From: Whitten, Paul
Sent: Wednesday, 4 September 2019 7:57 AM
To: Grillakis, Vasiliky
Cc: Williames, Glen
Subject: RE: Major Development Referral - PLN17/0618 - 27 - 45 Best Street and 102 - 114 Scotchmer Street, Fitzroy North

Drawing Nos. A-TP1-100, A-TP1-101, A-TP1-102, A-TP1-103, A-TP3-100, A-TP3-101, A-TP3-102 and A-TP4-101 Revision No. 02 dated 14 May 2019

PROPOSED DEVELOPMENT AT 27-45 BEST & 102-114 SCOTCHMER STREETS FITZROY NORTH

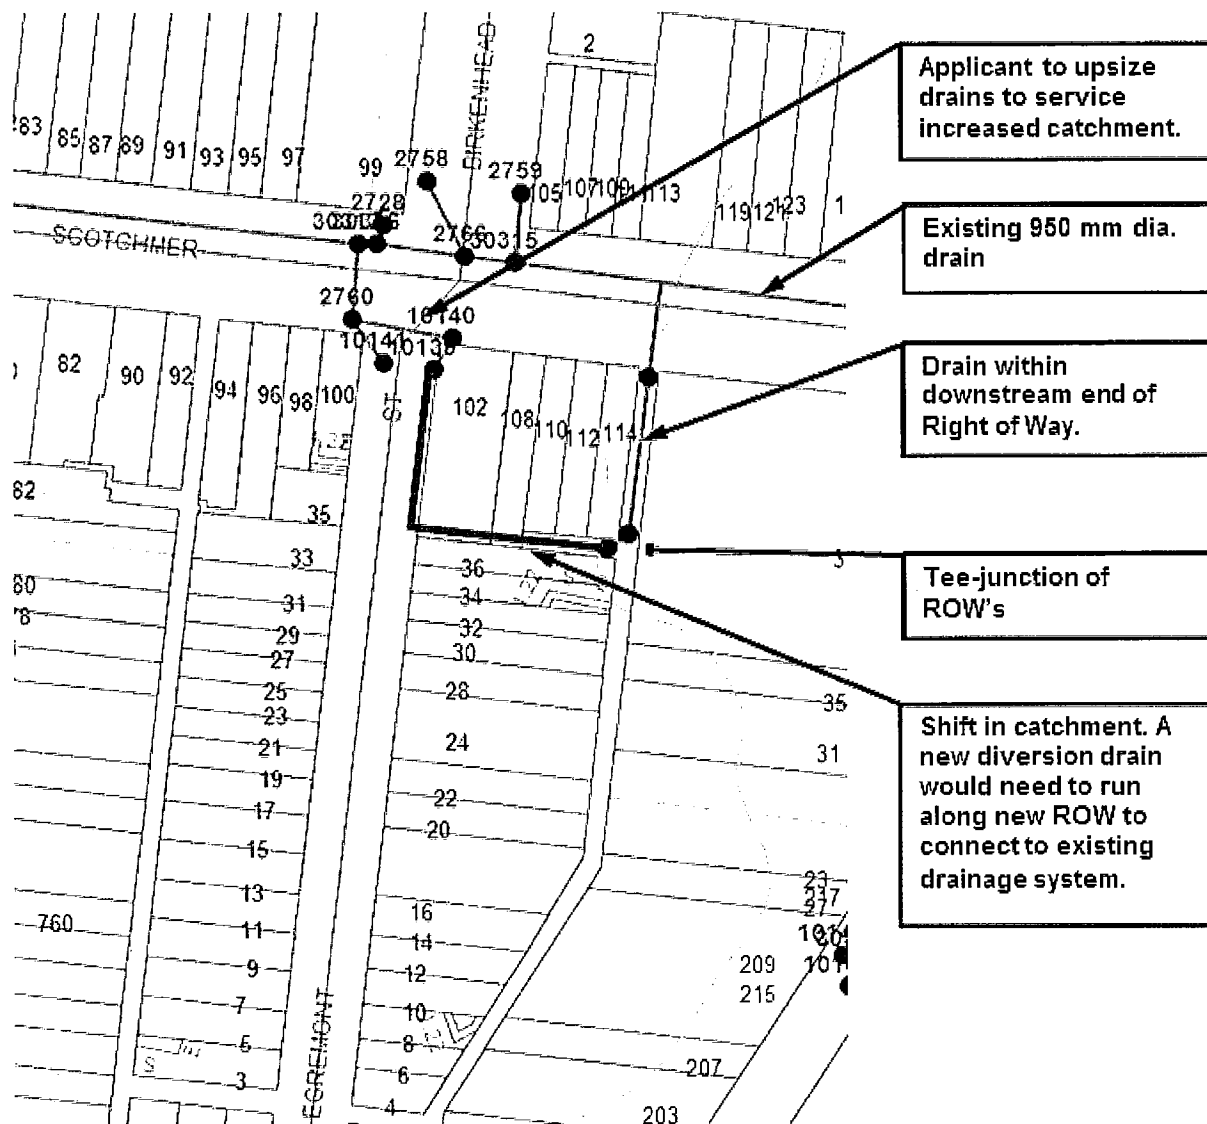
According to Council's drainage maps, an underground drain runs along the northern section of the Right of Way that connects to the Scotchmer Street drain (for a distance of around 28 metres, from Scotchmer Street to the tee-junction of the Rights of Way). This drain section functions to collect surface run-off for the Right of Way which extends further south. The Scotchmer Street end of the Right of Way is at the downstream end.

If the building were to be constructed as shown on the application drawings, the drain section from Scotchmer Street would need to be decommissioned. The new building and the acquisition of the Right of Way would effectively block overland flow along the existing Right of Way south of the site. The new east-west aligned Right of Way would have a natural slope from west to east (and the new ninety-degree junction of the Rights of Way would now create a low point). Therefore, major drainage works would be required in order to drain the area south of the site (currently, the existing Right of Way functions to drain the area south of the site).

- The construction of the new east-west aligned Right of Way would necessitate the construction of a new diversion drain to connect to the main drain in Scotchmer Street.

- A new diversion drain, commencing at the east end of the new east-west aligned Right of Way and connecting to the existing underground drain at the Egremont Street/Scotchmer Street intersection must be constructed to Council's satisfaction and at the Permit Holder's cost. The developer must also locate and verify utility service locations for new drain alignment and depth.

Basement 02 Plan

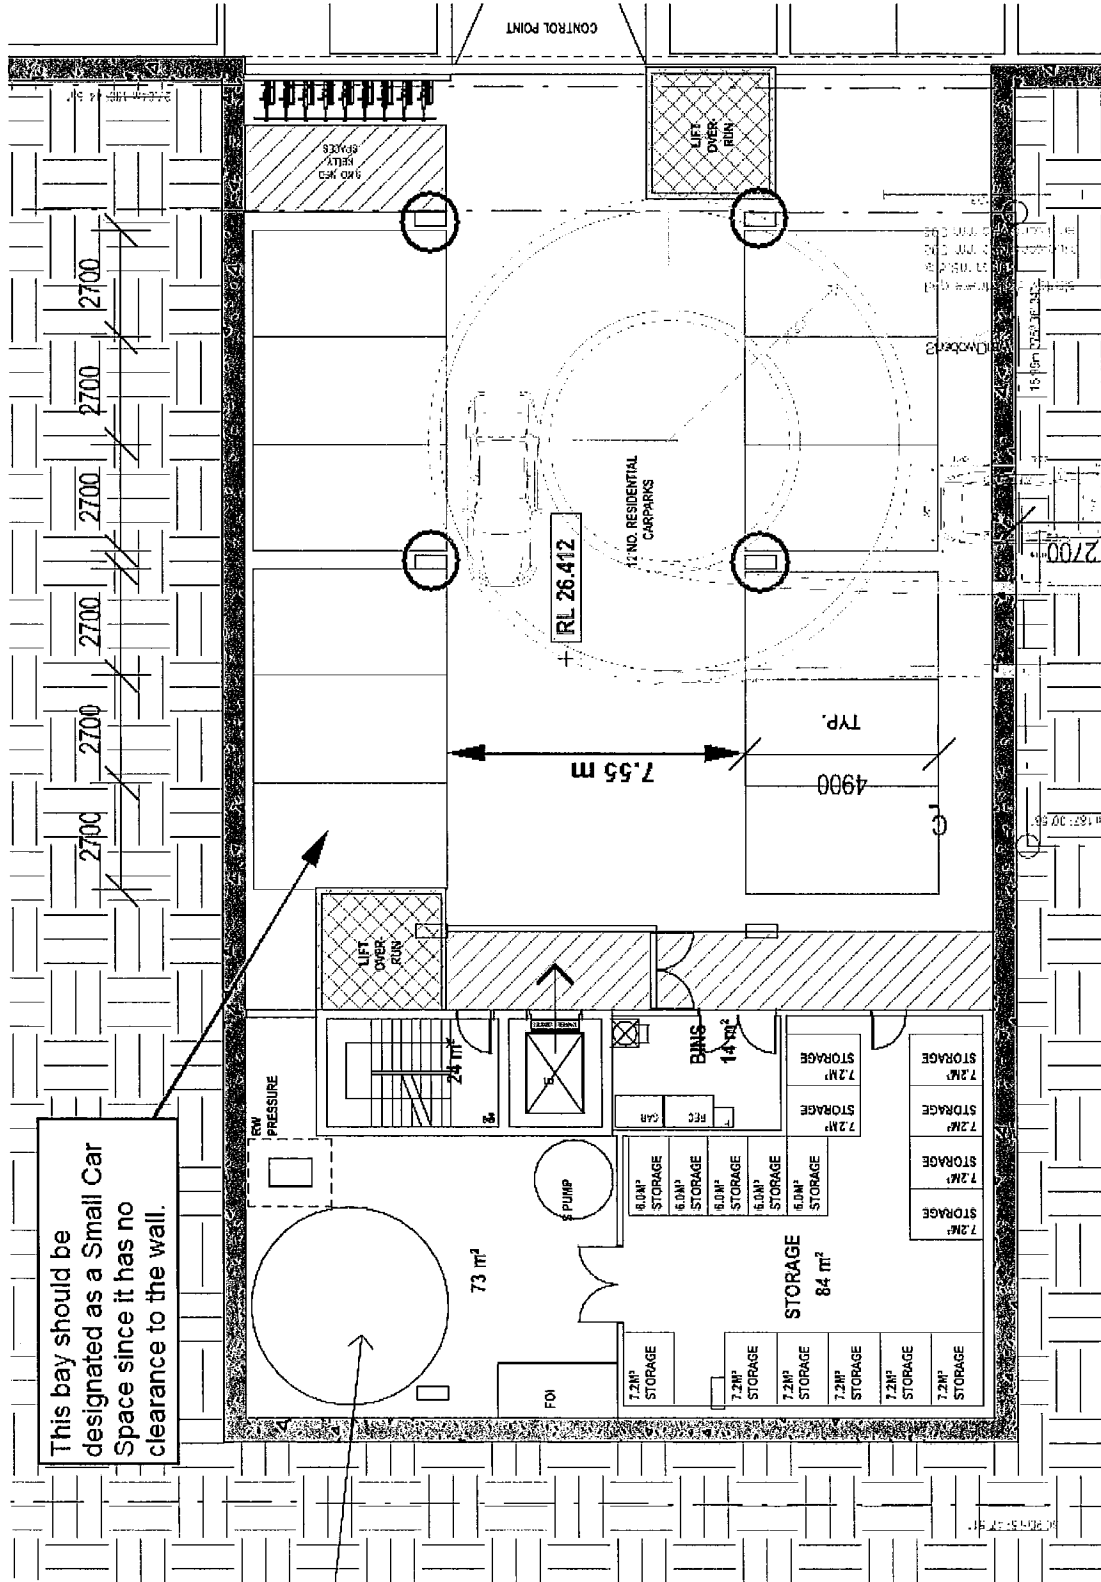
This bay should be designated as a Small Car Space since it has no clearance to the wall.

Loading Dock and Vehicular Entrance at Ground Level

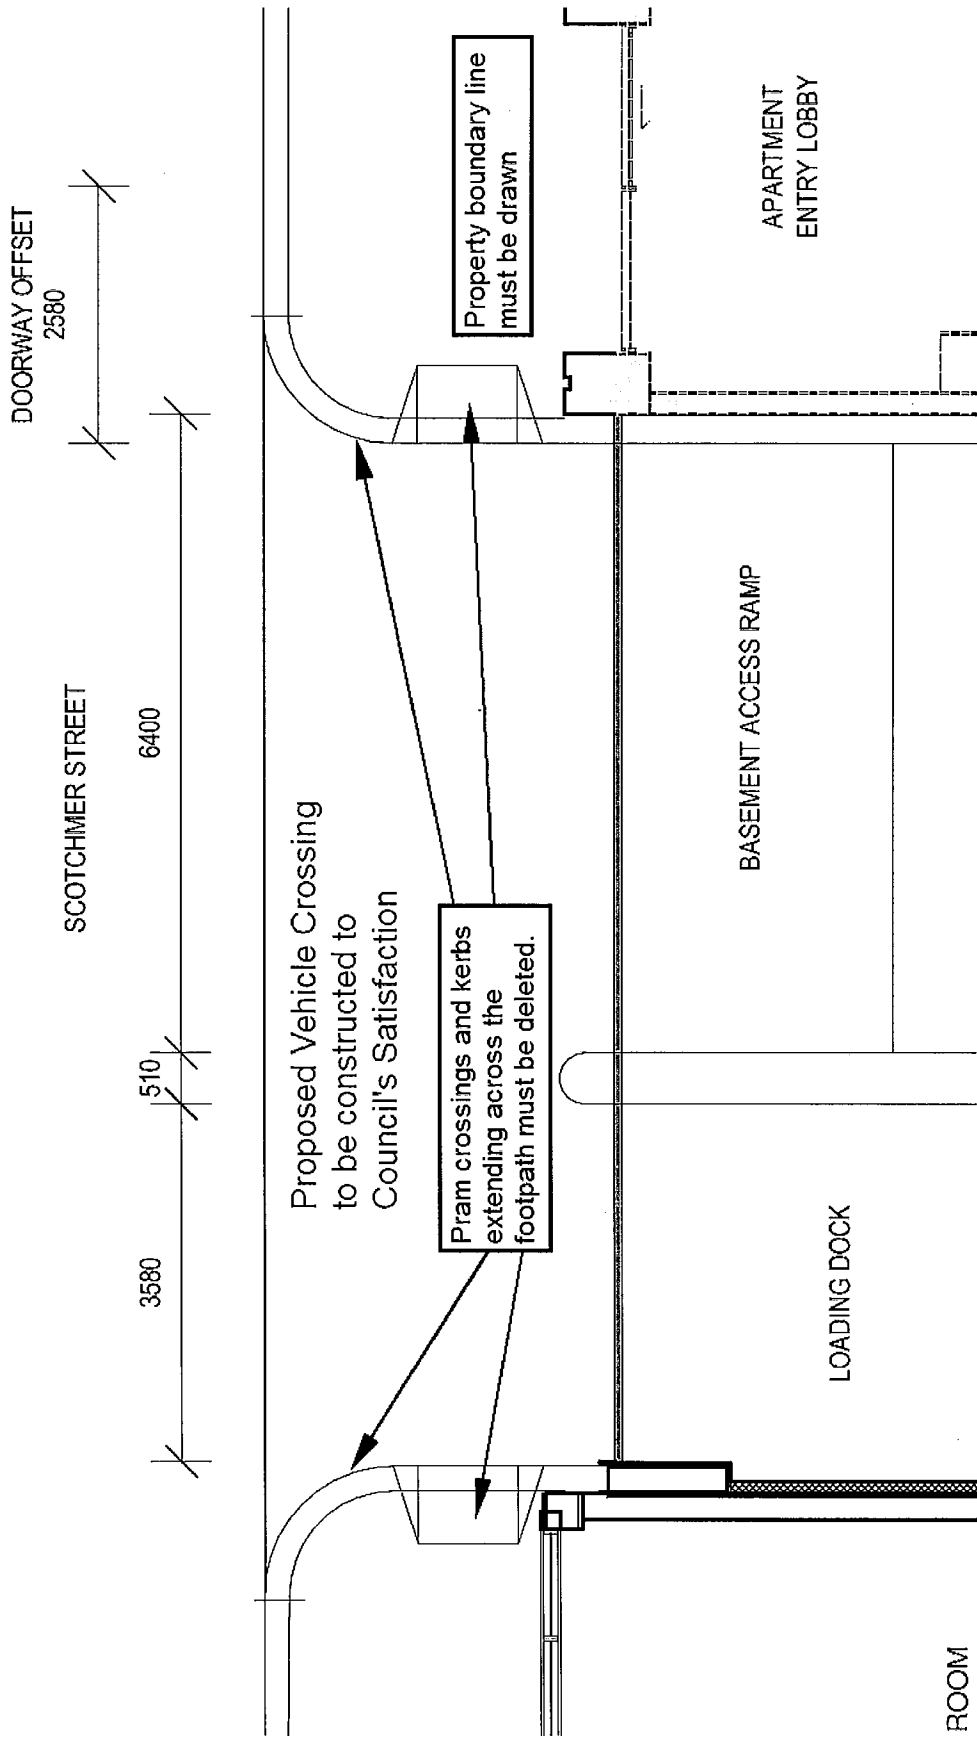
Visibility of Pedestrians at Loading Dock Entrance	Visibility at the entrance of the loading dock is restricted. How does the applicant intend to address this?
Loading Area Basement 01 Plan	Loading bays and aisle have not been dimensioned on the drawings.
Loading Area Swept Path Diagrams MGA Ref: MGA19011-AT01-03 MGA Ref: MGA19011-AT01-04 MGA Ref: MGA19011-AT01-05 Date: 18 December 2018	The swept path diagrams for the waste collection vehicle and a van are considered satisfactory. The sizes of these vehicles have not been specified on the swept path diagrams.
Other Items	
Turning Movements at Ninety-Degree Right of Way Junction	The swept path diagrams for the B99 design vehicle negotiating the proposed ninety-degree junction of the existing north-south aligned Right of Way with the new east-west aligned Right of Way, are considered satisfactory.
Junction of Egremont Street and New East-West aligned Right of Way	Not provided.

Visibility – Loading Dock	Applicant to address restricted visibility of pedestrians along Scotchmer Street as the driver of an articulated vehicle proceeds to exit the site.
Loading Area Basement 01 Plan	Loading bays and aisle are to be dimensioned on the drawings.
Loading Area – Swept Path Diagrams	Vehicle sizes must be specified on the swept path diagrams in the loading area on <i>Basement 01 Plan</i> .
Junction of Egremont Street and New East-West aligned Right of Way	Swept path diagrams for the B99 design vehicle are to be provided for vehicle turning movements at junction of the proposed east-west aligned Right of Way and Egremont Street. On-street parking on both sides of Egremont Street must be shown on the swept path diagrams.
Number of Car Parking Spaces	All parking spaces are to be numbered on the drawings.

Vehicle Crossing – Cross Section

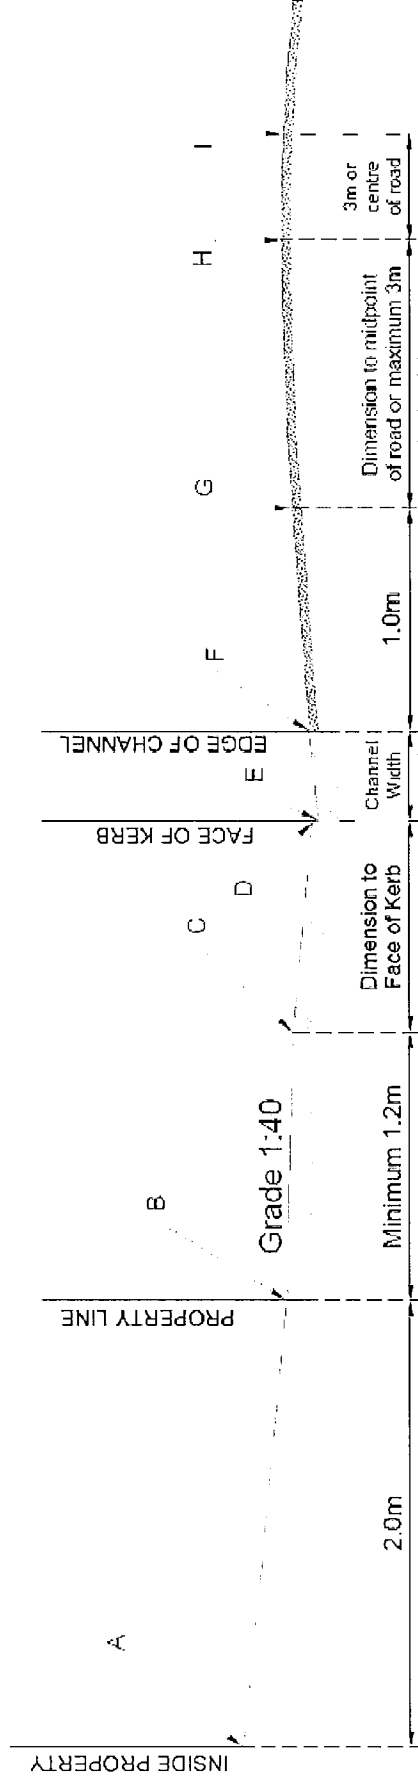
The designer is to submit a 1:20 scale cross section for each proposed vehicle crossing showing the following items:

- A. Finished floor level 2.0 metres inside property
- B. Property line surface level
- C. Surface level at change in grade (if applicable)
- D. Bullnose (max height 60mm) – must be clearly labelled
- E. Surface level at the bottom of the kerb
- F. Surface level at the edge of channel
- G. Road level 1.0 meter from the edge of channel
- H., I. Road levels

- o Please note the cross section must be fully dimensioned. As shown in the sketch below.
- o Please show both the existing and proposed surface.
- o The maximum allowable cross-fall between points B and C is 1:40 (2.5%).
- o A bullnose (max 60mm) is permitted at point D, however not compulsory.
- o The levels shown must be exact reduced levels, to three decimal points. Interpolation of levels is not acceptable.
- o The designer must demonstrate that an 85th or 99th percentile vehicle profile can traverse the design cross section as per the Australian/New Zealand Standard ground clearance template (AS/NZS 2890.1:2004).
- o Significant level changes to the existing footpath level B to C will require additional level design either side of the proposed crossing.
- o Please include any additional levels or changes in grade that are not shown in the diagram.
